**SUSQUEHANNA STEAM ELECTRIC STATION
PROPOSED LICENSE AMENDMENT NO. 285 FOR
UNIT 1 OPERATING LICENSE NO. NPF-14 AND
PROPOSED LICENSE AMENDMENT NO. 253 FOR
UNIT 2 OPERATING LICENSE NO. NPF-22 EXTENDED
POWER UPRATE APPLICATION RE: REACTOR SYSTEMS
TECHNICAL REVIEW REQUEST FOR ADDITIONAL
INFORMATION RESPONSES
PLA-6250**

**Docket Nos. 50-387
and 50-388**

Attachment 2 to PLA-6250
Non-Proprietary Version of the Request for
Additional Information Responses

Request for clarification/supplemental information in response to PLA-6209.

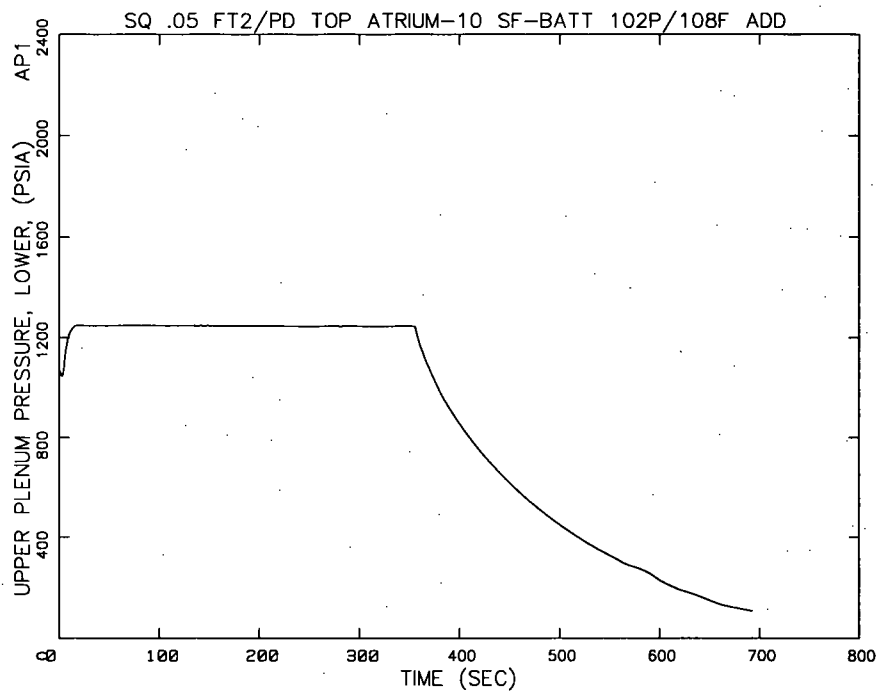
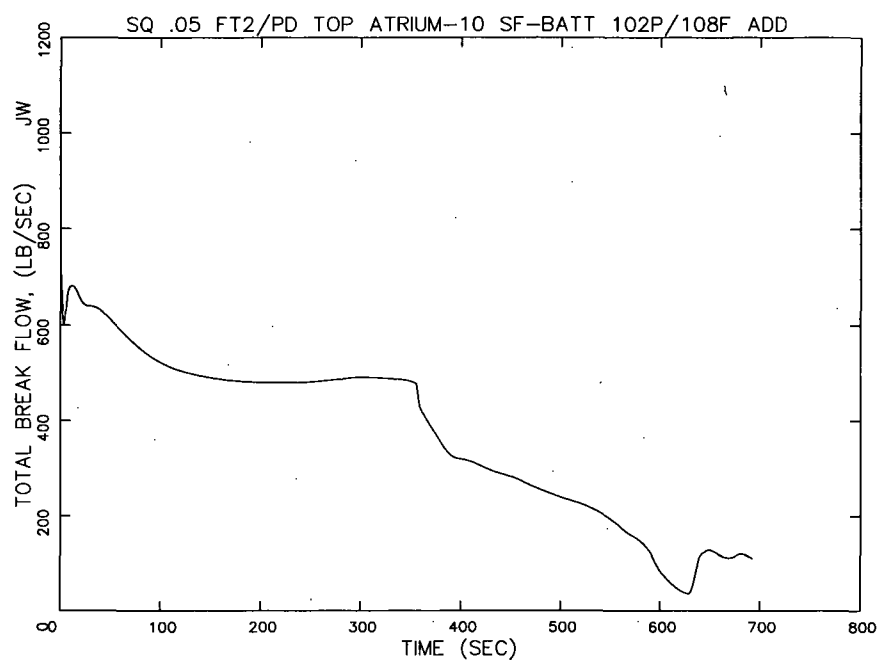
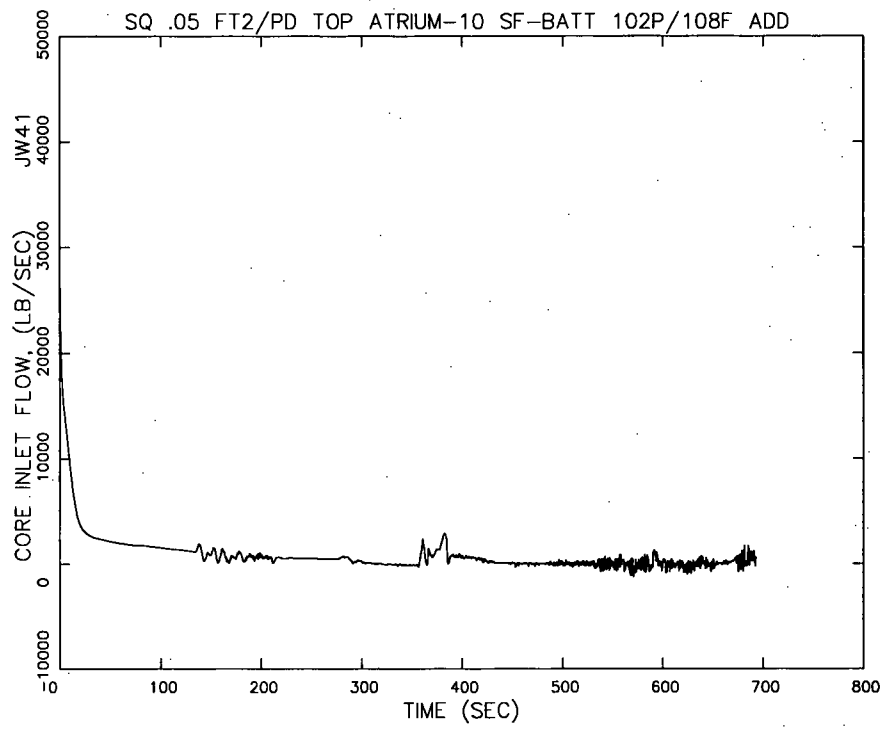
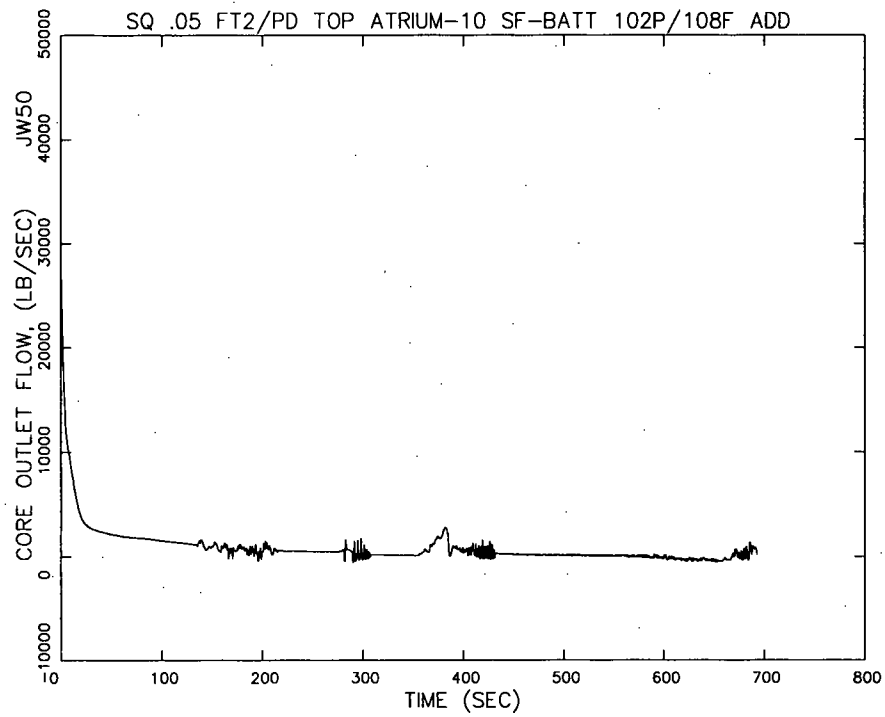
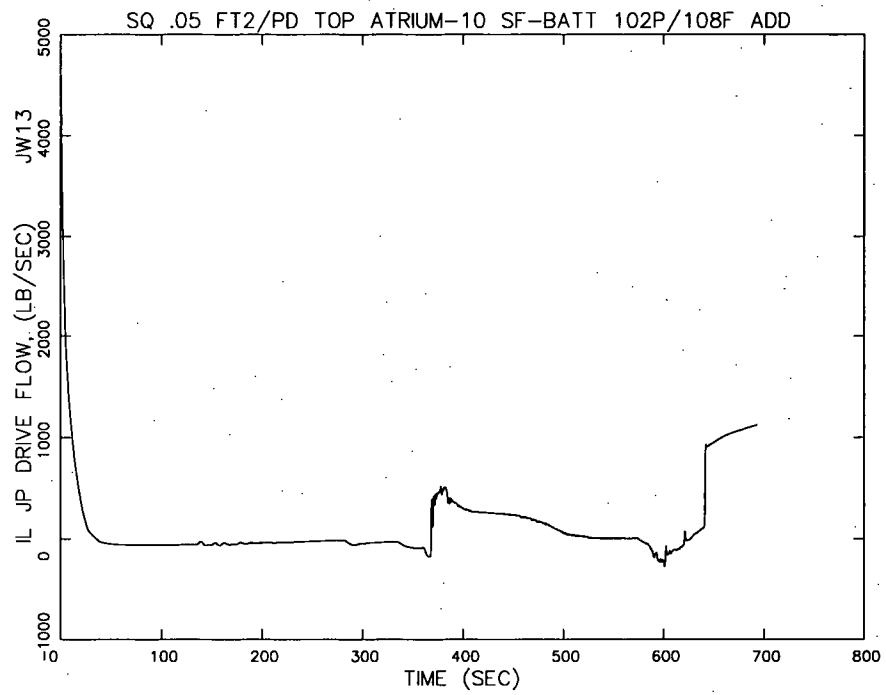
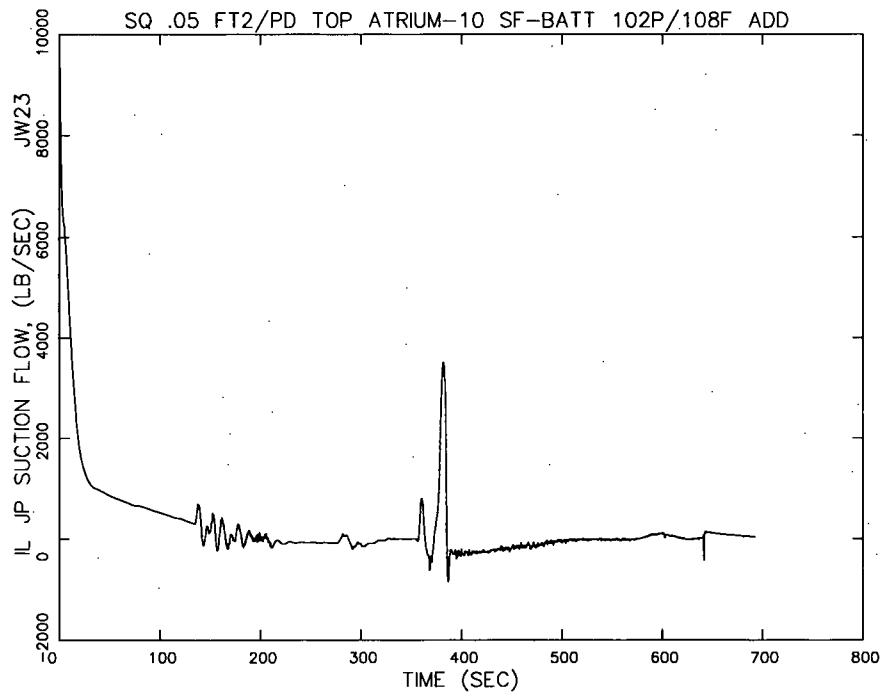
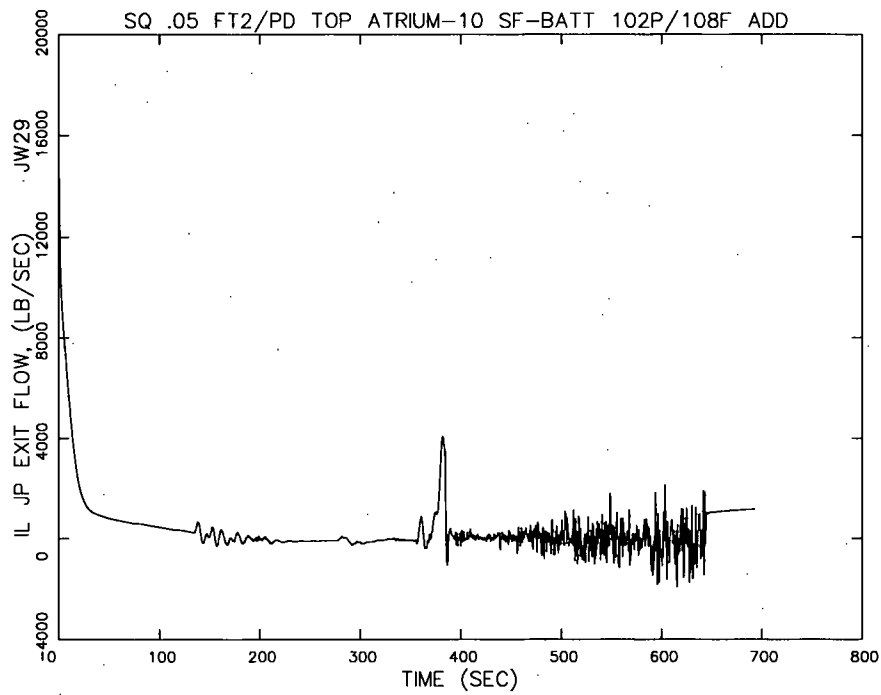
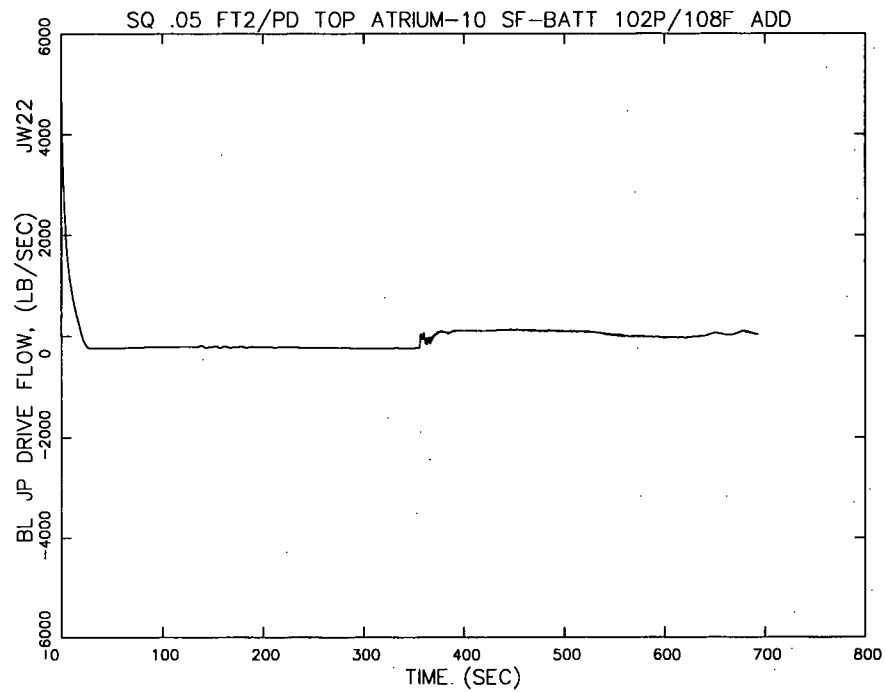
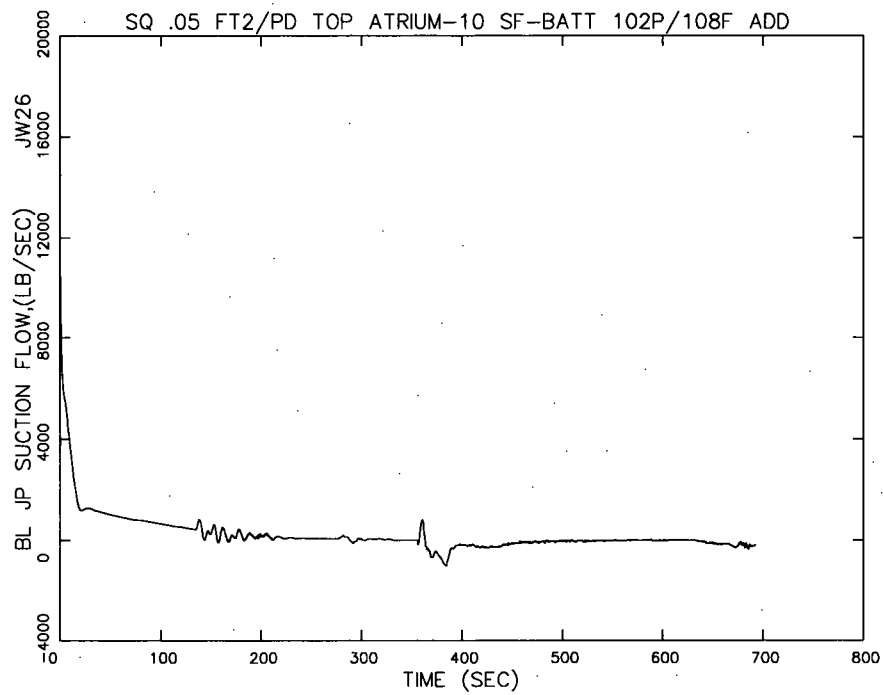
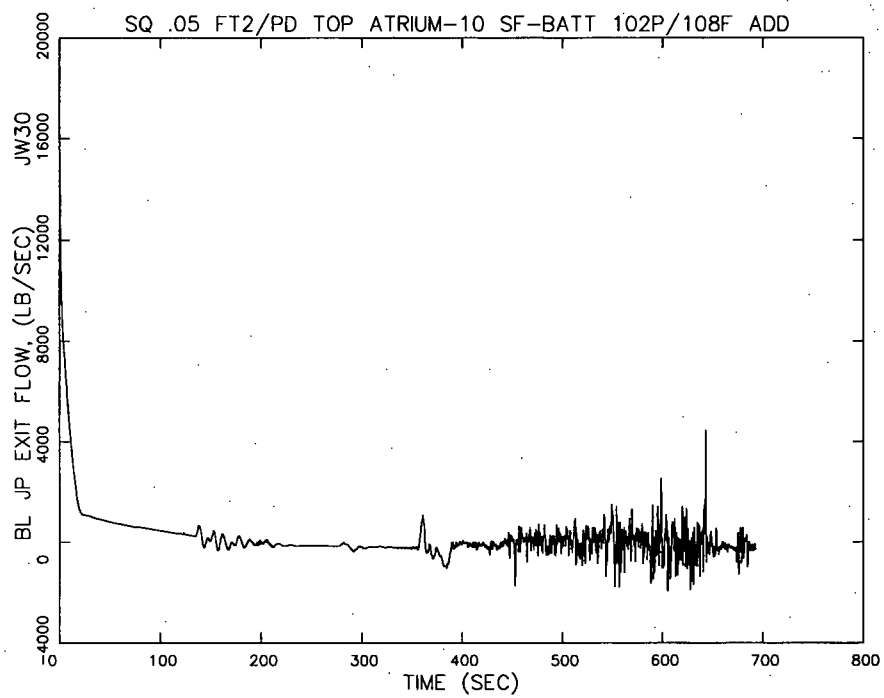
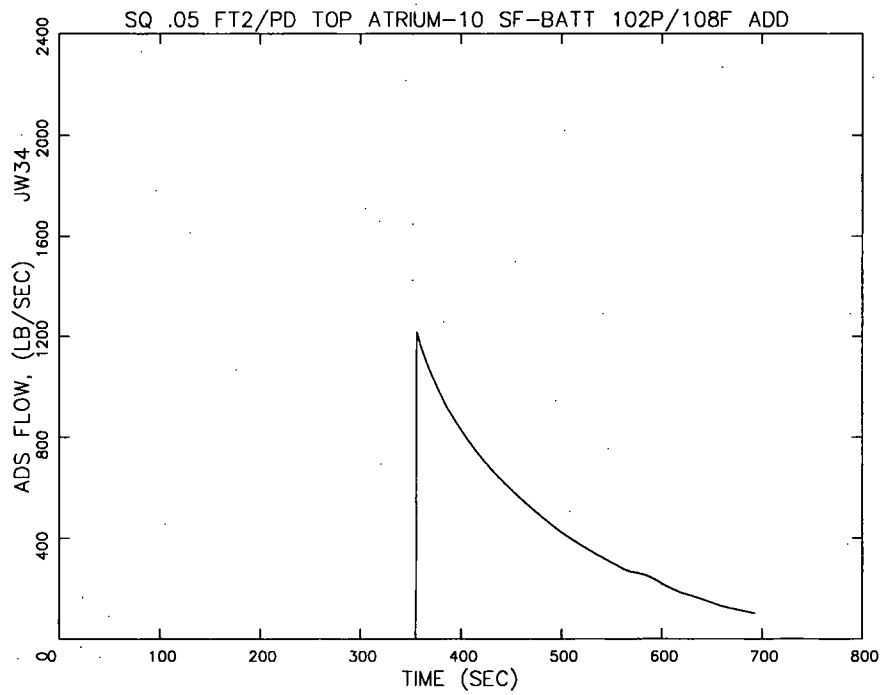
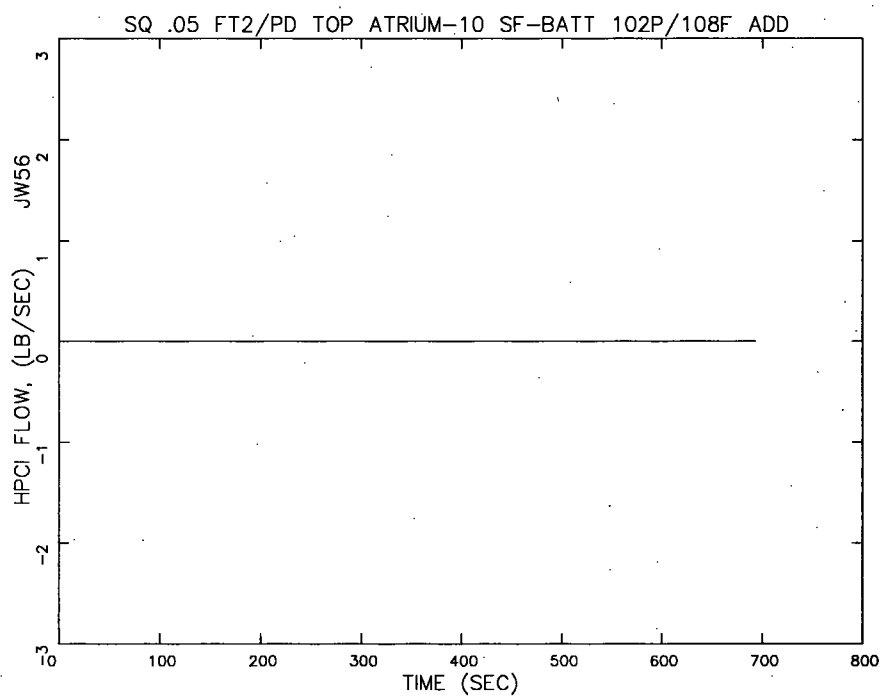
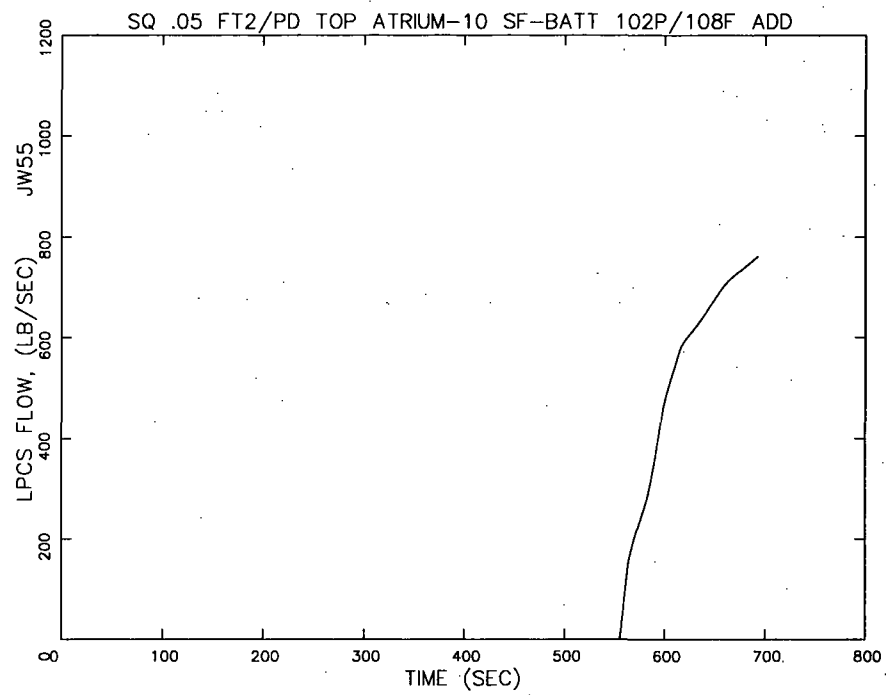
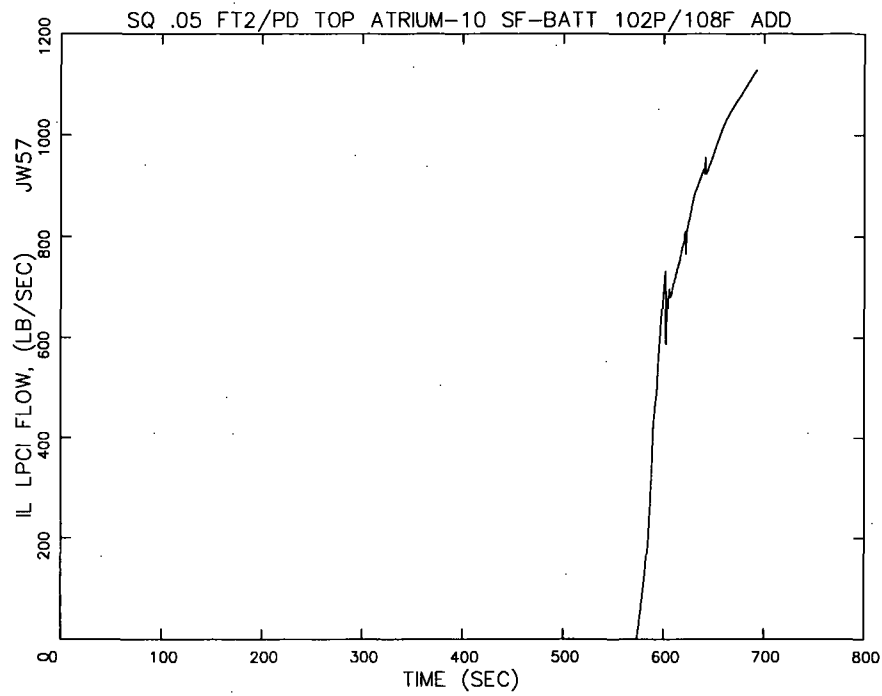
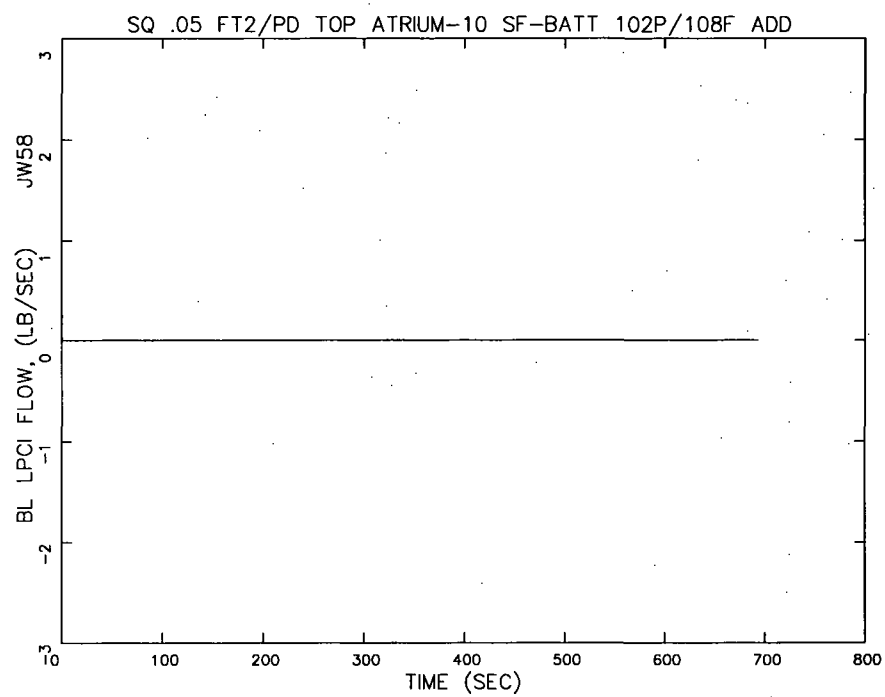
The staff performed a small break LOCA with break size less than 0.1 ft² at recirculation pump discharge side. The break characteristics include initial core flow of 108 Mlbm/hr, 102% power, top-peaked axial power profile and SF-BATT. The staff found the PCT in this break size range (less than 0.1 ft²) is much more limiting compared to break size at 0.7 ft² case. Please provide small break LOCA analysis result at break size of 0.05 ft² with same break characteristics. Please include major parameter plots as shown in the LOCA report (EMF-3242P, Revision 0) for TLO large break LOCA.

AREVA performed the requested small break calculation for 0.05 ft², initial core flow of 108 Mlbm/hr, 102% power, top-peaked axial power profile and SF-BATT. The PCT for this small break was calculated to be 1296°F, which is lower than the limiting large break PCT and lower than the limiting small break PCT calculated with AREVA methods. The sequence of events for the requested small break calculation is provided in Table A.1 followed by a set of major parameter plots similar to the LOCA report.
